**Area Walk-By Checklist (AWC)**

Fermi 2 Seismic Walkdown Guideline  
Area Walk-By-Checklist

NJPR-12-0043

(Picture #6)

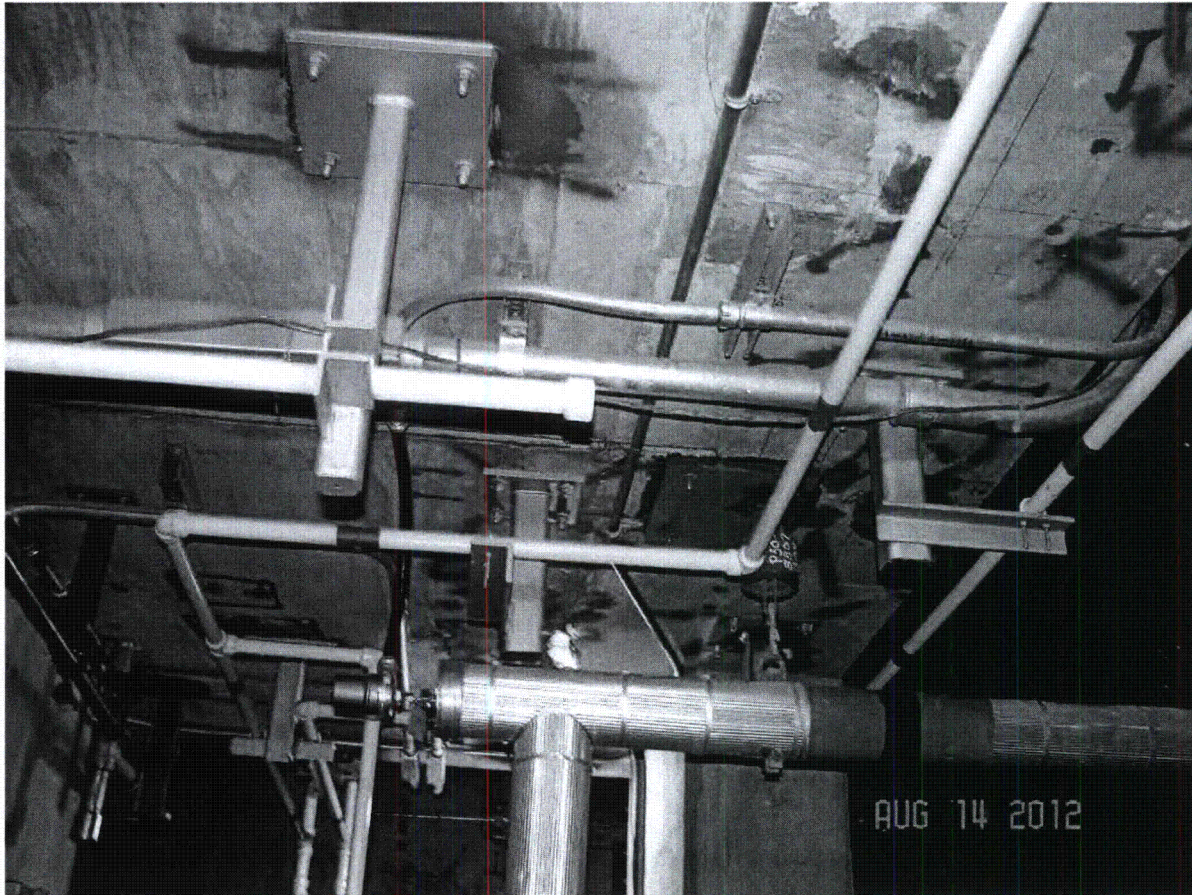
*Cable trays and conduit are too far away. Asset is protected from above by a concrete ceiling. (See Picture 6).*

(DSCN0071)

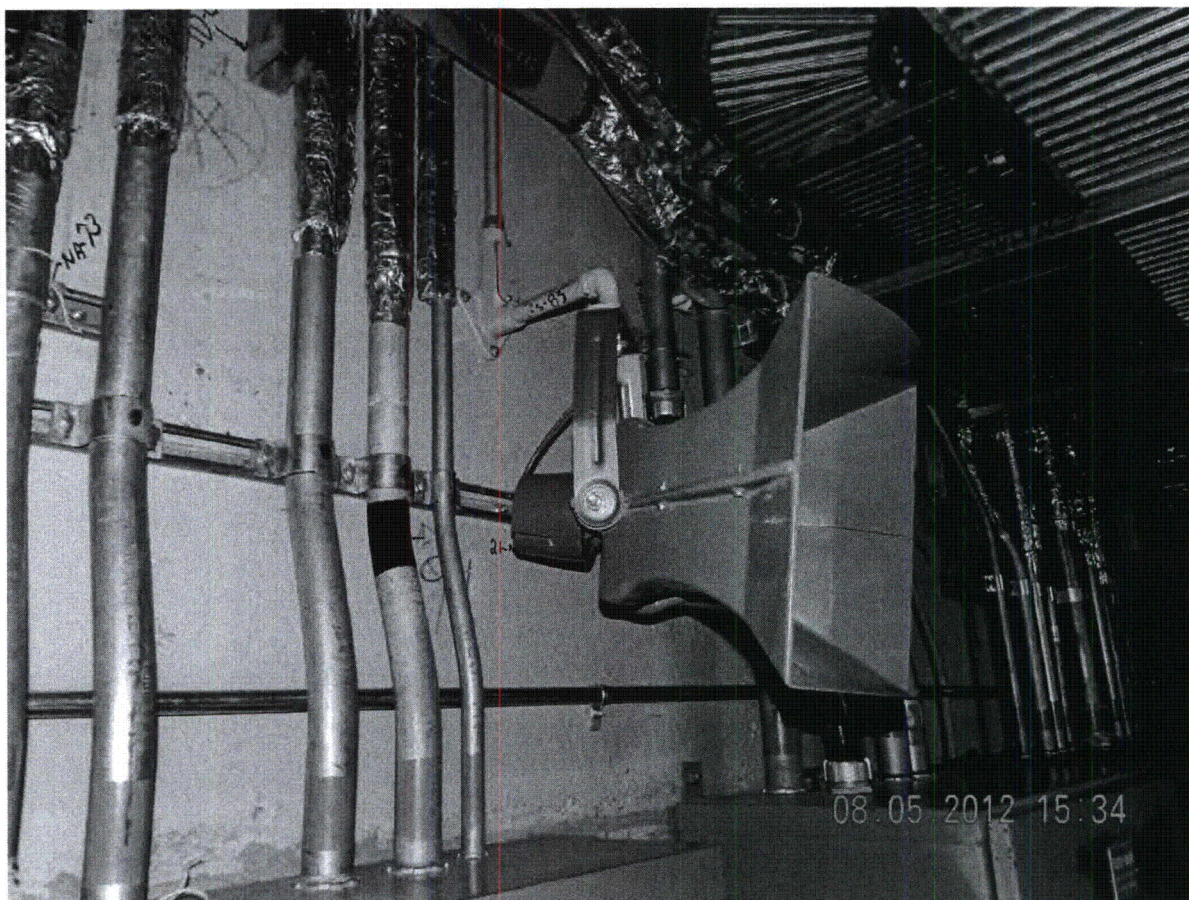
*Lights on chains & cables. Fire wrap around cables loose in places, but not a seismic concern. Foil outer casing is light weight and would not fall or cause damage in a seismic event. HVAC mounted on seismic supports. Gatronics mounted on rigid conduit over Div. II breaker panel - See CARD 12-26630. (SEE PICTURES DSCN0071, DSCN0072) ~ DSK 10/10/12*

(DSCN0201)

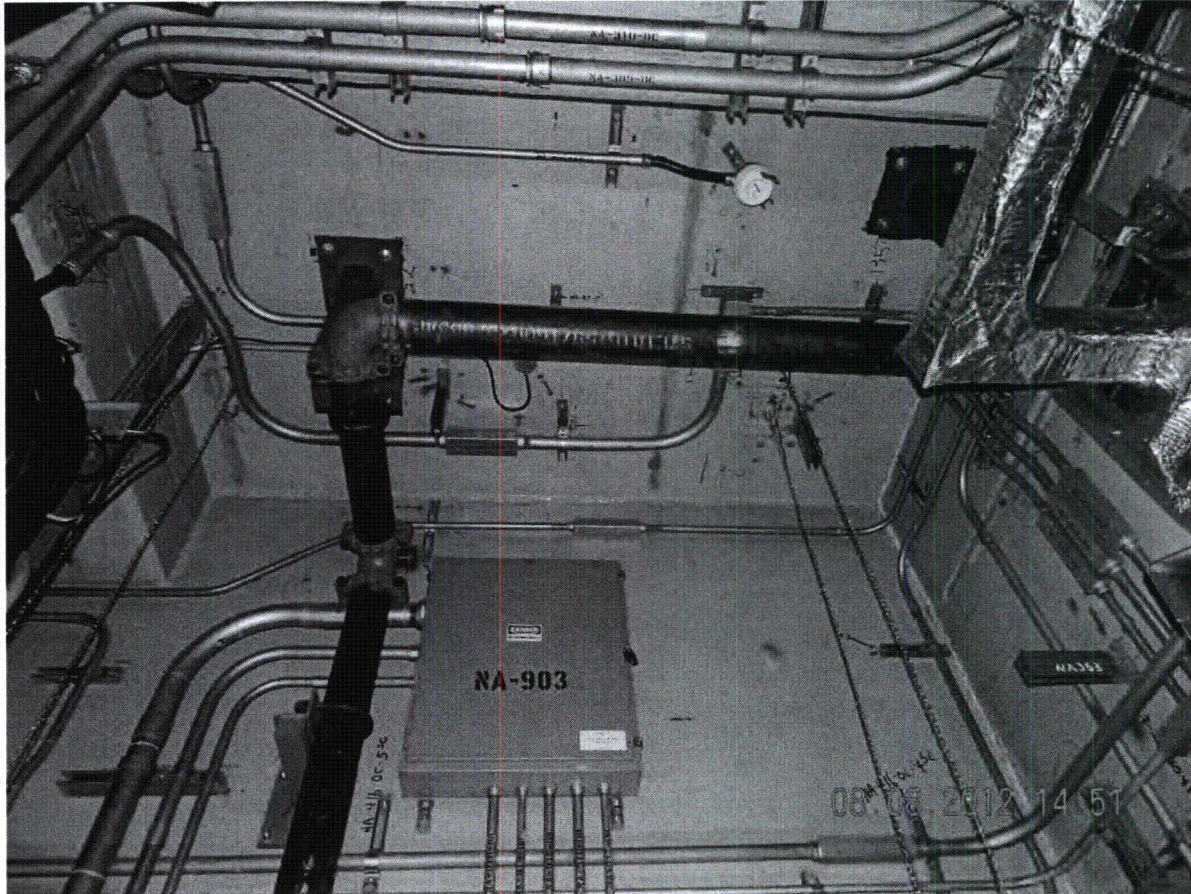
*No water pipes observed.*

*Area protected by Cardox System.*

"Halon Piping above, Ref. Dwg. M-5327"

(Photo DSCN 0319)

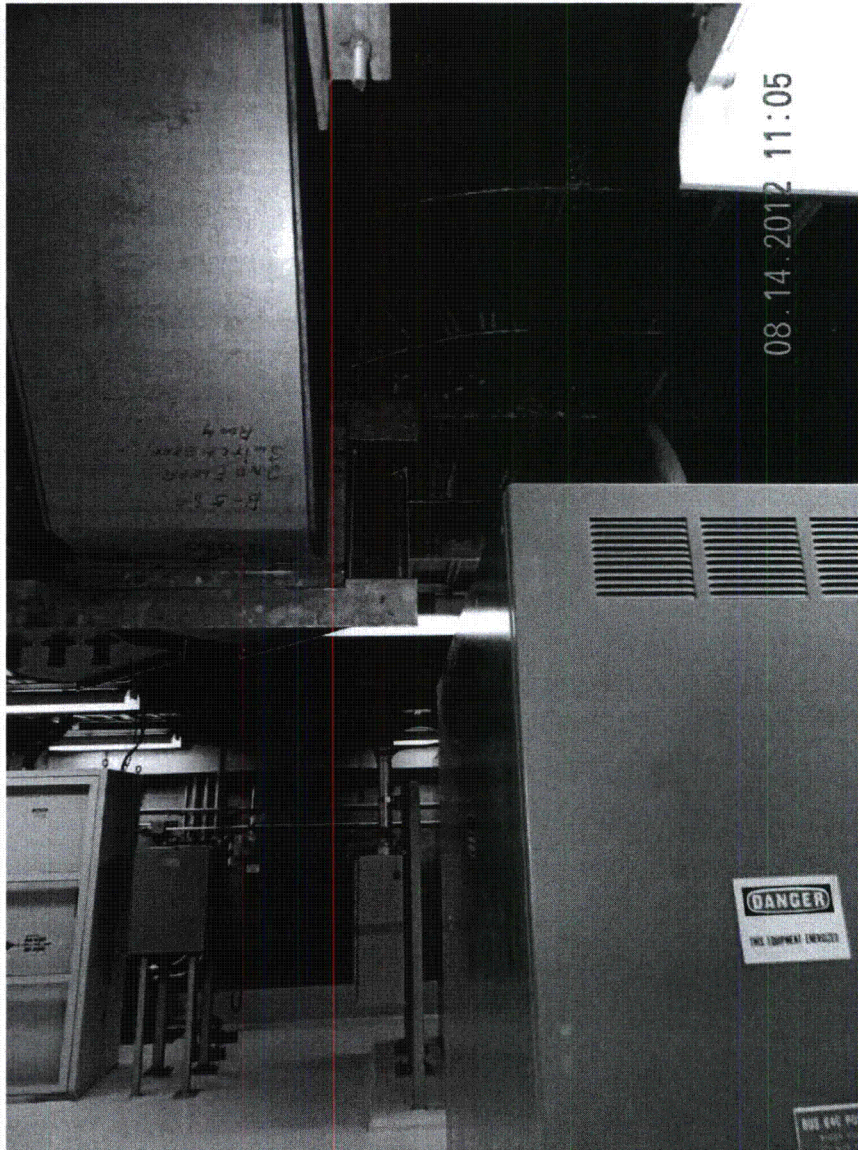
*Overhead cable trays have adequate seismic clearances. HVAC duct and tray supports are all robust. Trays have longitudinal bracing. Seismic clearance between asset R1400S001C and HVAC duct on west side of asset is 4". Per Dwg. M-5433, Rev. B (posting TCEDP 26116, Date 06/94), a minimum clearance of 6" is required (see Photo DSCN 0319). Initiated CARD 12-27959.*

(Photo DSCN 0323)

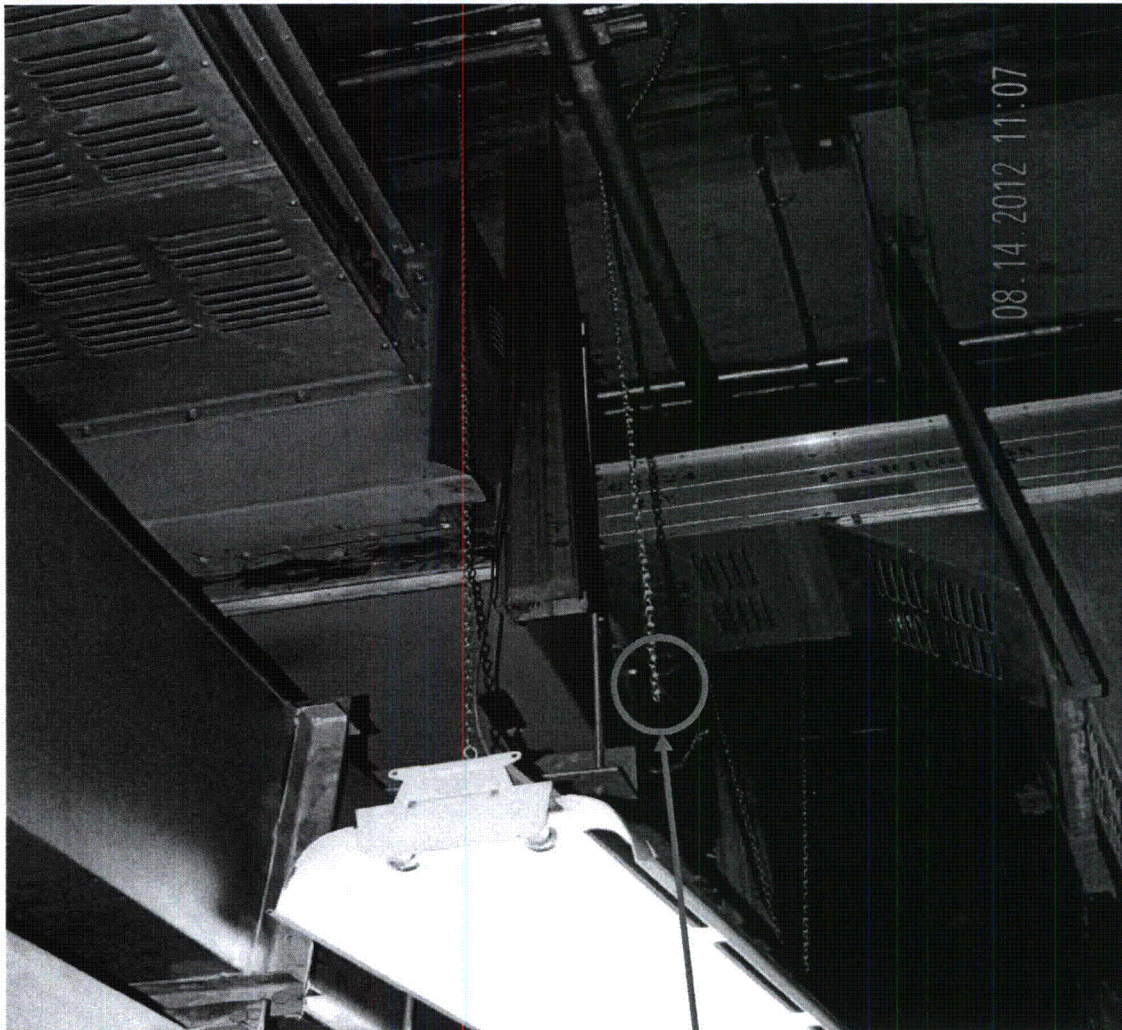
*No ceiling tiles in the area. With one exception, lights are supported by cables and chains. Light fixture to and south of asset R1400S001C has one chain detached (see Photo DSCN 0323). Fixture is resting against stiffener on nearby HVAC duct. Cable is supporting fixture where chain is detached. CARD 12-27093 was initiated to correct condition.*

(DSCN0134)

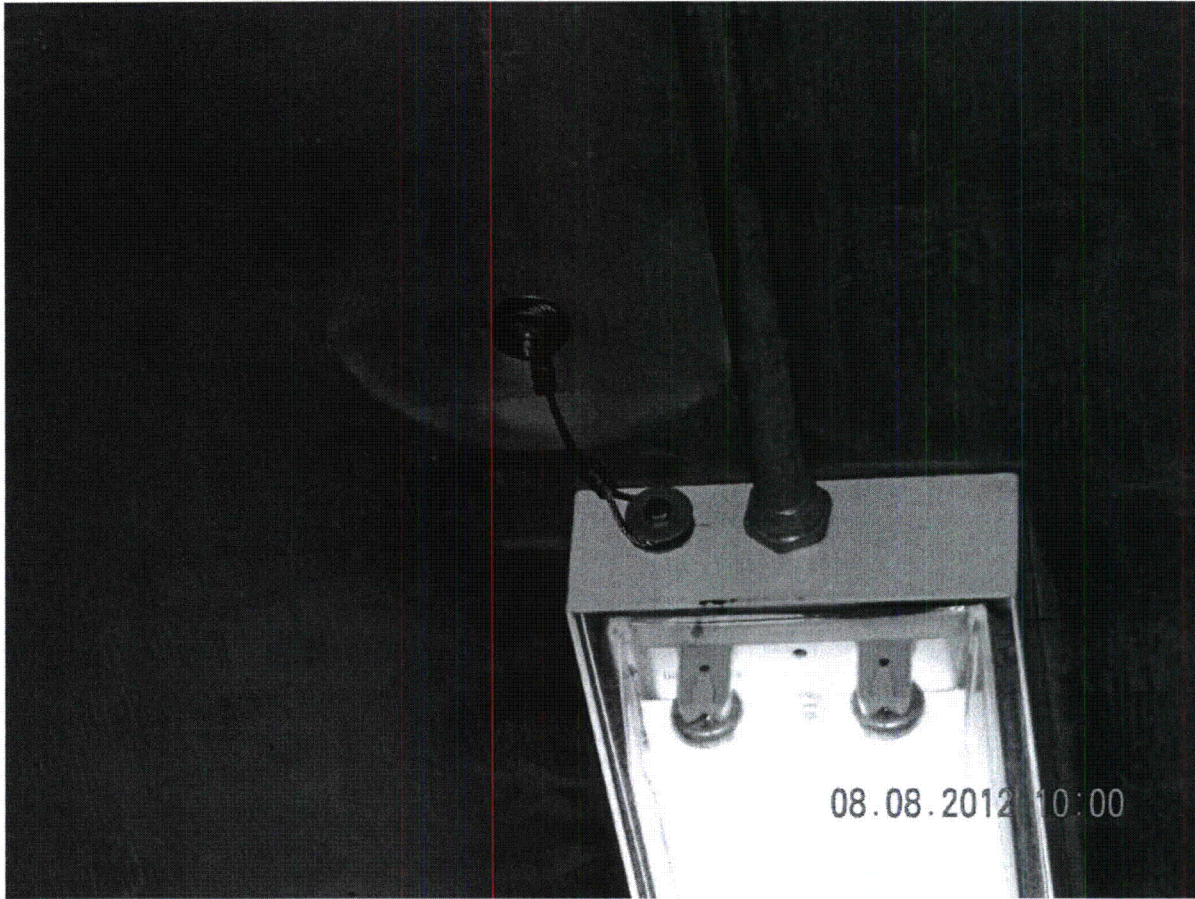
*HVAC duct – could not verify hangers covered with silver insulation/fire wrap – NOTE: duct is wall-mounted and at such a height & distance from the battery racks that the HVAC system does not pose a seismic risk. Lights have plastic covers and chain with cable, emergency light fixture appears adequate*

*Lights have plastic covers and chain with cable, emergency lights acceptable – robust.*

(DSCN0144)

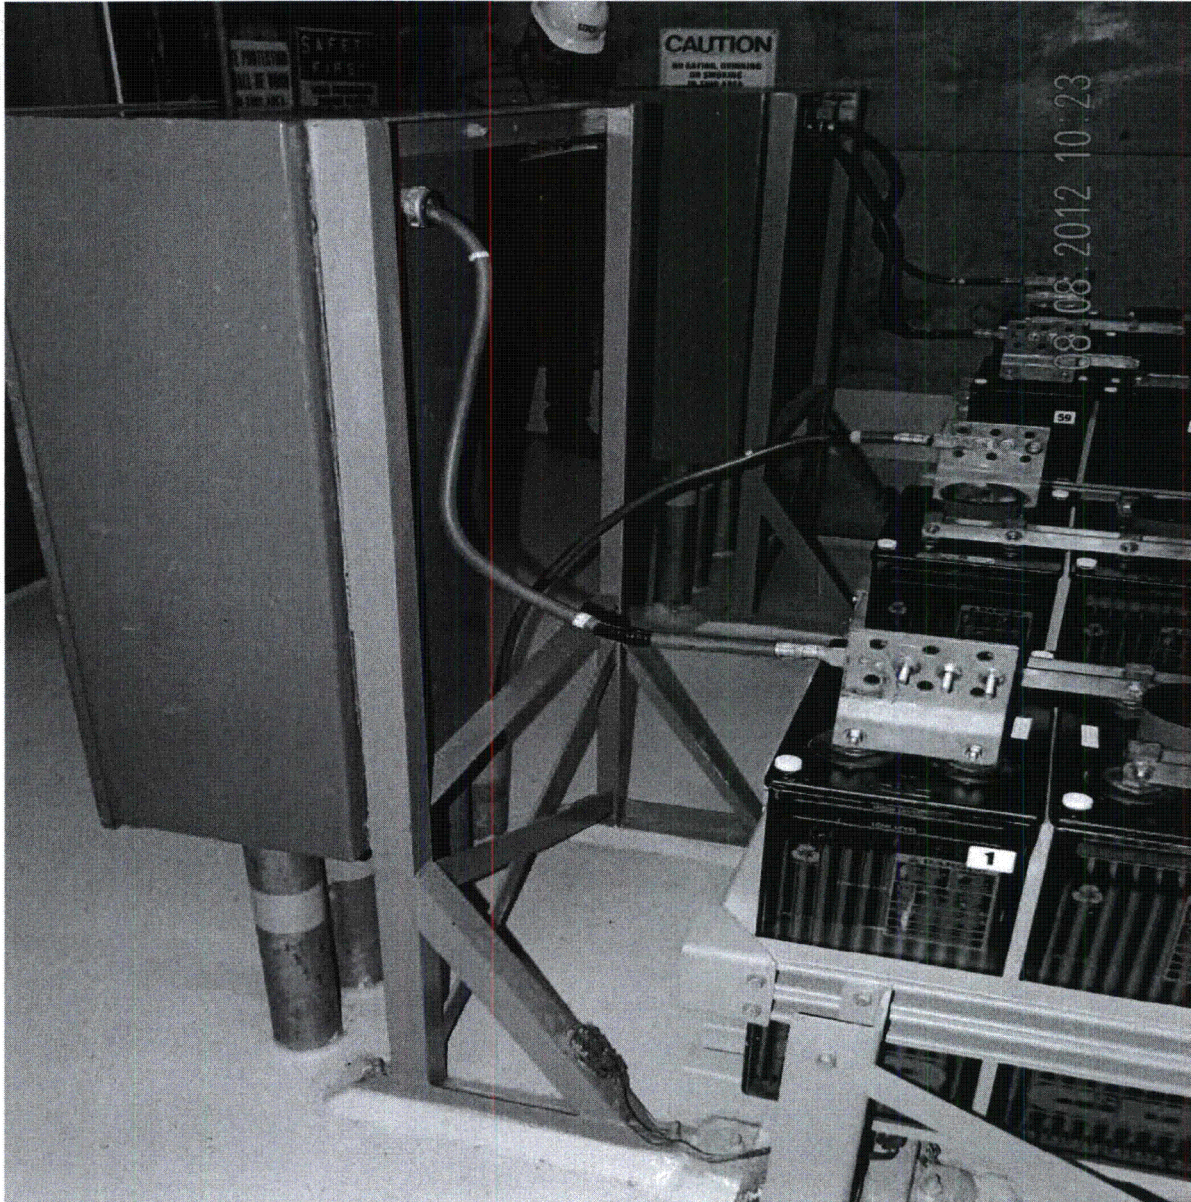
*Cabinets R3200S008A, R3200S011 and R3200S008B on frame anchored to floor. 3/8"Ø anchors with 1½" of thread extended above washer – acceptable see drawing E-2833-10. (See Photo DSCN0144)*

*Area is clean.*

(DSCN0208)

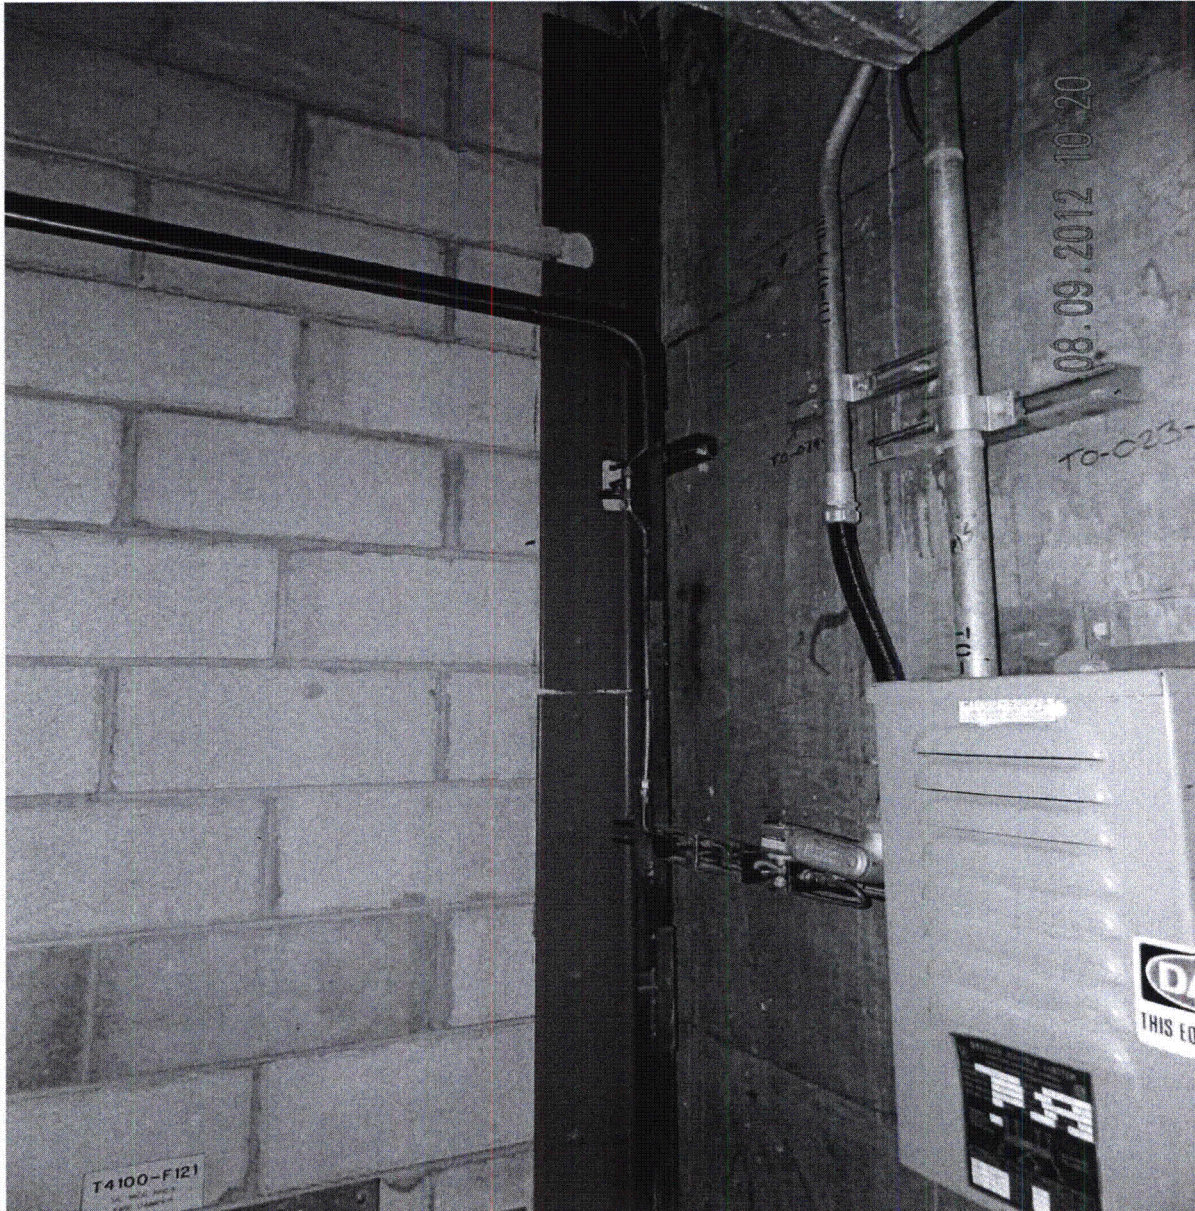
*Adjacent fire wall anchored to the floor. Adjacent Div. I cabinet anchored to the floor. Air handling unit T4100B033 approximately 15" from R3200S016 evidence of corrosion at the base. Corrosion is minor, and condensation moisture issues are being addressed by placement of absorbent socks at condensation location.  
(See Photo DSCN0209, DSCN0208, DSCN0217 and DSCN0224)*

(DSCN0209)

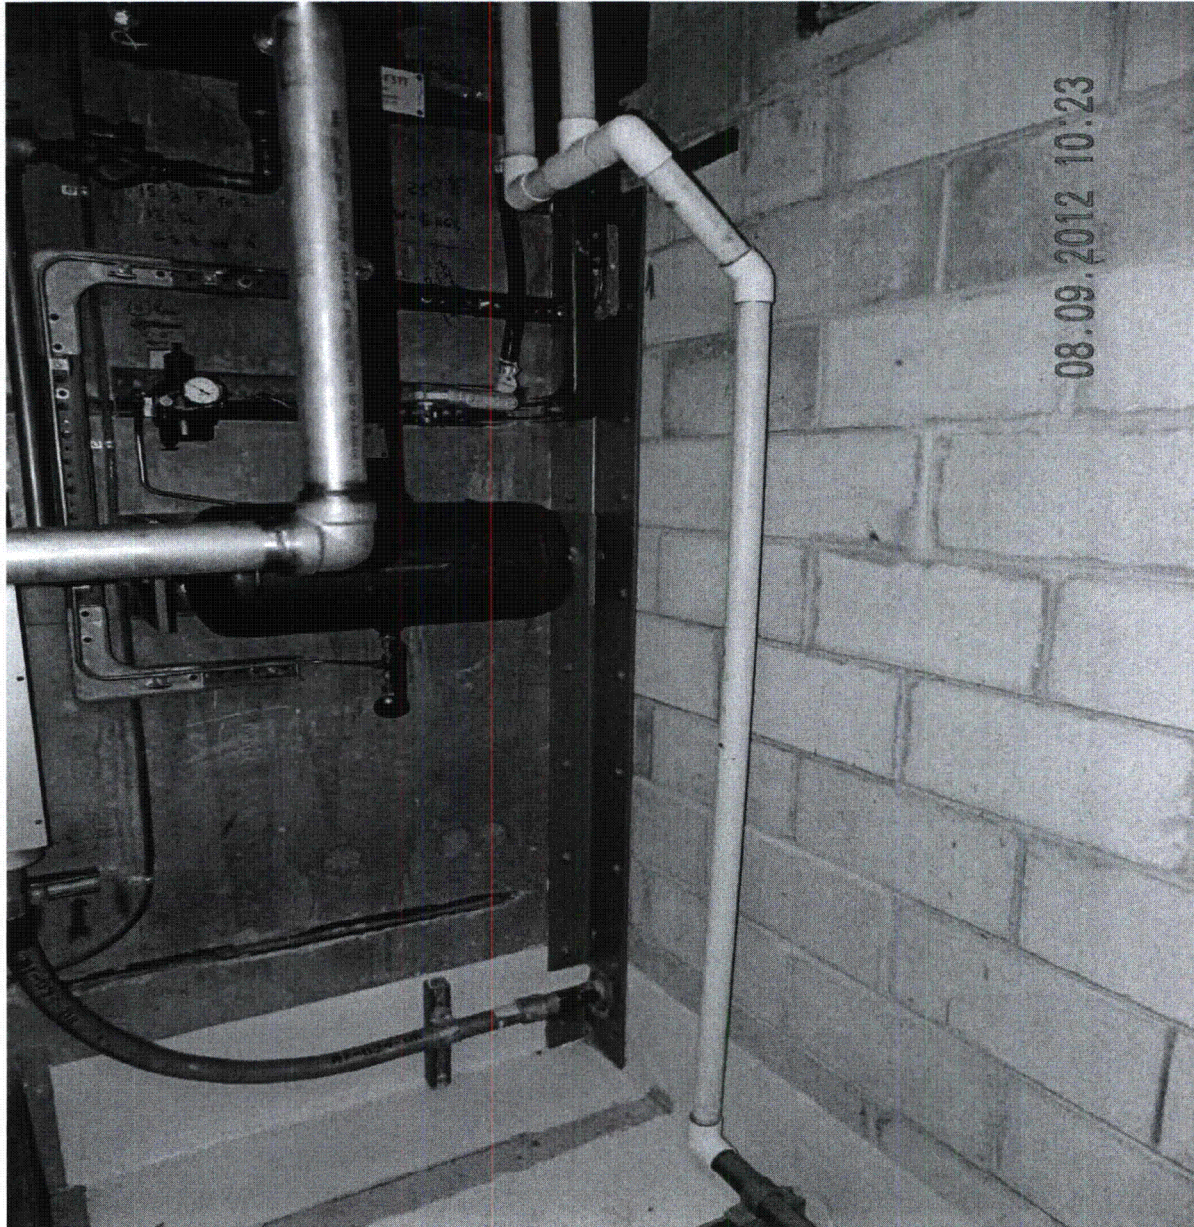
*All items above cabinet, copper pipe, tube track and HVAC ducts appear seismically supported. Copper pipe connected to valves P50F701 & P50F377, part of instrument air system.  
(See Photo DSCN0209, DSCN0210 and DSCN0224)*
